In the Matter of )  
)  
**ViaSat, Inc.** ) File No. SES- LIC-20120427-00404  
) Call Sign E120075  
Application for Authority to Operate Up to )  
4,000 Transmit/Receive Aeronautical-Mobile )  
Earth Stations in the Ka-band )

**COMMENTS OF ROW 44, INC.**

January 11, 2013

Figure 1: ViaSat's Plot of Grating Lobe EIRP Exceeding 25.138 for 25° skew

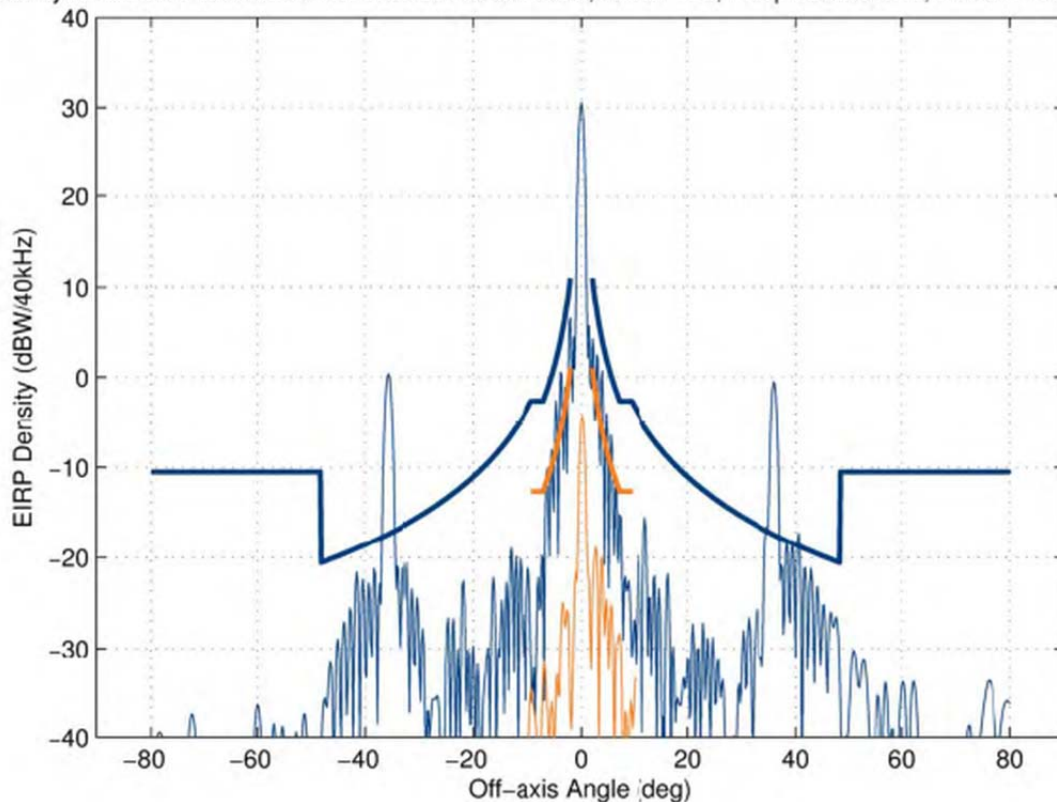
Figure 1, below, extracted from ViaSat's Exhibit C,<sup>1</sup> illustrates the predicted grating lobes that exceed the 25.138 limits. Because ViaSat provided plots for only a few specific skew values (25 degrees here), a complete quantification of ViaSat's likelihood to interfere with other satellites has not yet been provided. The analysis provided below seeks to remedy this omission.

ViaSat's plots from their application (e.g., Figure 1 above) provide the off-axis EIRP values only for (operational) skew values of 0, 25, 60, 85 and 90 degrees. As is evident in Figure 2, a single plot in the 25 degree skew-range is insufficient to depict the actual skew range over which ViaSat's EIRP exceeds the 25.138 mask. Figure 2 provides no quantitative indication as to the amount of exceedance for any of the skew values in that range.

In conclusion, considering grating lobes and mispointing, ViaSat has not identified all scenarios capable of producing interference, and should both (1) provide measured antenna pattern data for a range of skew angles, and (2) identify a proper method of mitigating pointing error.

**Figure 2: Estimated Skew Ranges where Grating Lobes Cause Interference**

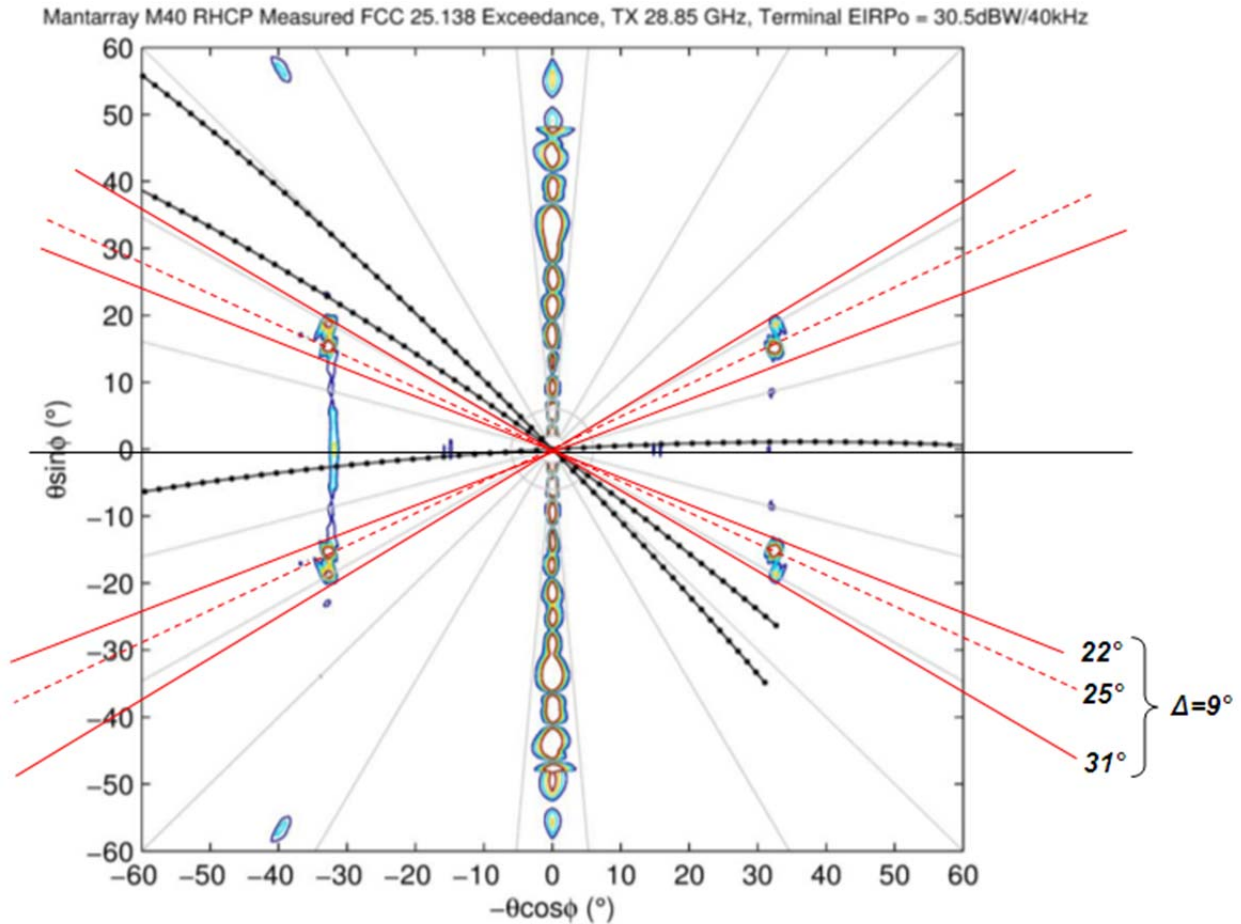
Figure 2 on the next page, modified from 'Figure '3 of ViaSat's Technical Description,<sup>2</sup> illustrates the locations of the grating lobes that exceed the Section 25.138 criteria.

As an estimate of the skew-ranges over which the grating lobes will exceed the Section 25.138 benchmarks, solid lines are drawn tangent to the regions indicating the highest values of EIRP exceedance. In these narrow regions alone, it is evident that the Section 25.138 limits are significantly exceeded between skew values of  $22^{\circ}$  and  $31^{\circ}$  for positive skew values, as well as a similar region from  $-22^{\circ}$  to  $-31^{\circ}$  for negative values of skew.

(Note also that the left-half of the plot even suggests that Section 25.138 exceedance occurs across the entire range of skew values between  $0^{\circ}$  and  $31^{\circ}$ .)

**Figure 3: US Regions Where Interference from ViaSat's Grating Lobes is Likely**

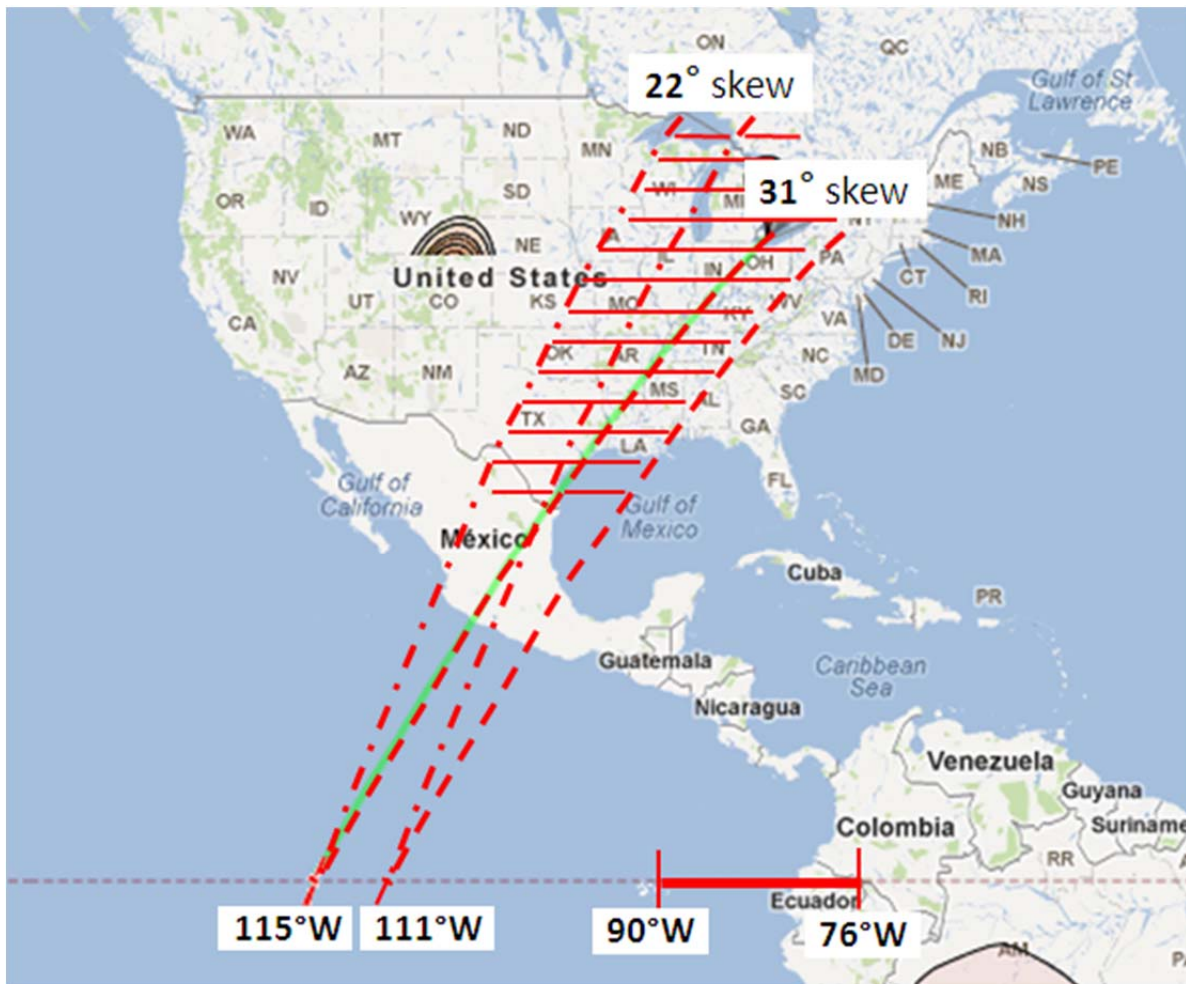
Figure 3, on the next page, illustrates the geographical impact of the exceedance boundaries of Figure 2 for a 'flat' aircraft. While pointing to either of ViaSat's satellites, there will be a geographical region within which an antenna pointing to either of ViaSat's satellites will invoke a skew value falling within the range of skew values over which ViaSat violates the Section 25.138 EIRP limits.

As can be seen (again, for a 'flat' aircraft), the geographical span over which pointing to either of ViaSat's satellites involves skew values between 22 to 31 degrees extends over a broad portion of the continental US, thereby demonstrating that the region over which interference created by the Mantarray antenna grating lobes will occur is far broader and of greater concern than ViaSat acknowledges in its application.

As mentioned, Figure 3 indicates the region for a 'flat' aircraft. However, for a 4-degree pitched aircraft, the region is expanded approximately 2.9 degrees east, and 4.1 degrees west in longitude. That is, for an aircraft flying due east at a 4 degree pitch, the 31 degree skew

contour (to ViaSat's satellite at 111.1 West) will occur at longitudes approximately 2.9 degrees farther-east than that shown in Figure 3. As well, for an aircraft flying due-west at a 4 degree pitch, the 22 degree contour (to ViaSat's satellite at 115.1 West) will occur at approximately 4.1 degrees farther-west than Figure 3. In view of the fact that all cruising aircraft fly at 'pitch', this indicates that the effective geographical regions for interference will actually extend well-beyond those indicated in Figure 3 when long-term, real-world operating conditions are considered.

(Note also that skew values in the 22 to 31 degree range can be achieved even well-beyond the above-mentioned areas for aircraft engaged in banking maneuvers.)

**Figure 4 Skew Values for GSO Positioning Error Exceedance**

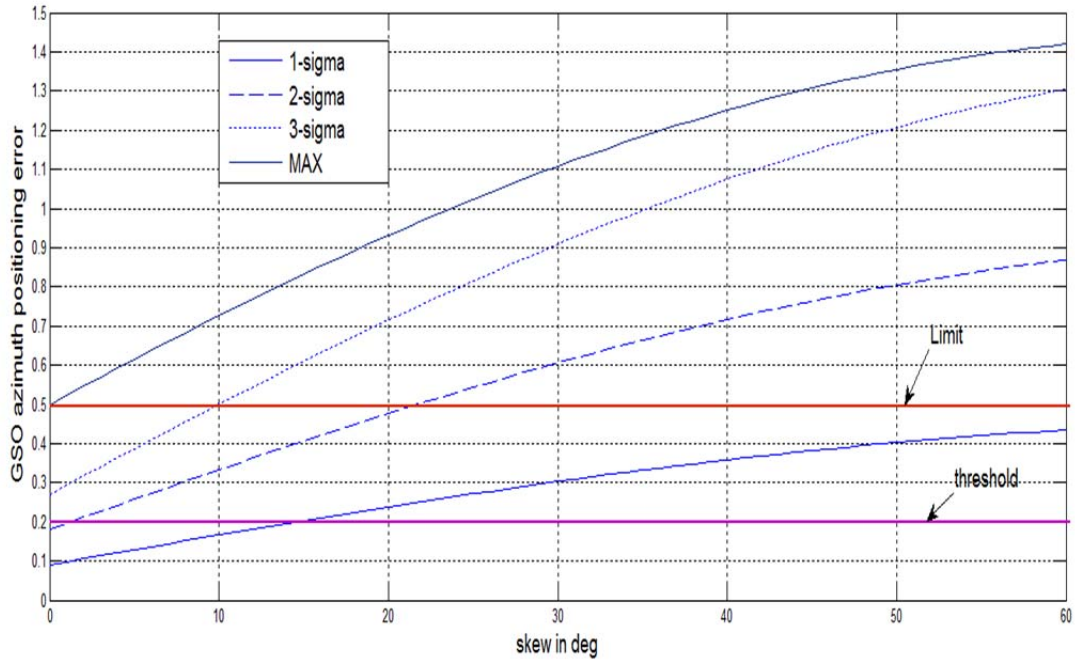
Figure 4, on the next page, presents a visualization of the range of skew values where the positioning error exceeds the threshold of 0.2 degrees and the limit of 0.5 degrees.

From even a ‘minimal-error’ perspective, the above plot, which provides more detailed data, it is seen that the threshold value of 0.2 degrees can even be exceeded by ‘one-sigma’ values over the skew angle range of approximately -15 to -50 degrees (and 15 to 50 degrees). Geographically this range involves aircraft within a region from the US East Coast, from Maine to Florida, up to a line approximately from Minnesota to Texas.

From a ‘maximal-error’ perspective, (i.e., considering three sigma values), the limit value of 0.5 degrees can be exceeded for skew angles from 10 to 60 degrees. As already discussed, within this realm, ViaSat’s misinterpretation of pointing error would not disable the transmitter for a wide range of skew and azimuth/elevation pointing error combinations. The associated potential for interference will occur over a broad portion of the United States.

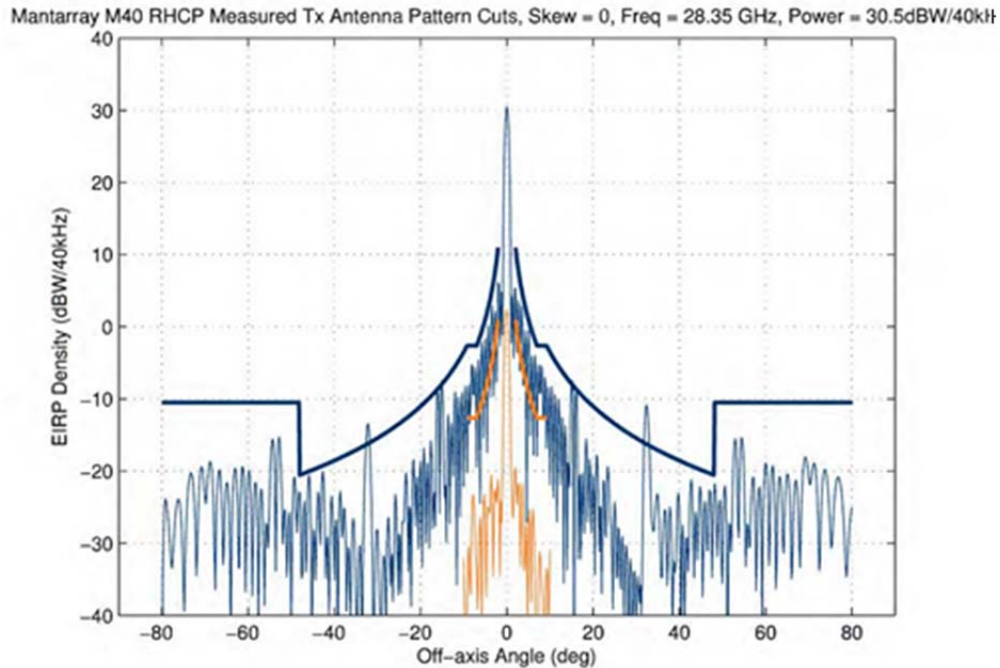
In general, uncontrolled grating lobes may be of substantial levels. Analysis has suggested that grating lobes may even rival the level of the antenna's main lobe itself.

In an attempt to suppress the grating lobes at 0 degree skew, the Mantarray antenna uses an established technique of shifting the antenna horns in the second row of the array by the width of one-half-horn. If manufactured perfectly, this design would result in the absence of grating lobes in the 0 degree skew pattern. However, even the smallest of imperfections prohibits the existence of this perfect array. These imperfections are evident in ViaSat's 0 degree skew plot below, where 1st order grating lobes are clearly present (at approximately each of  $\pm 17$  deg.,  $\pm 32$  deg., and  $\pm 54$  deg.). As is obvious, even though the Mantarray design attempts to eliminate them, the lobes are indeed present, and even at  $\sim \pm 32$  degrees violate the FCC EIRP mask significantly.
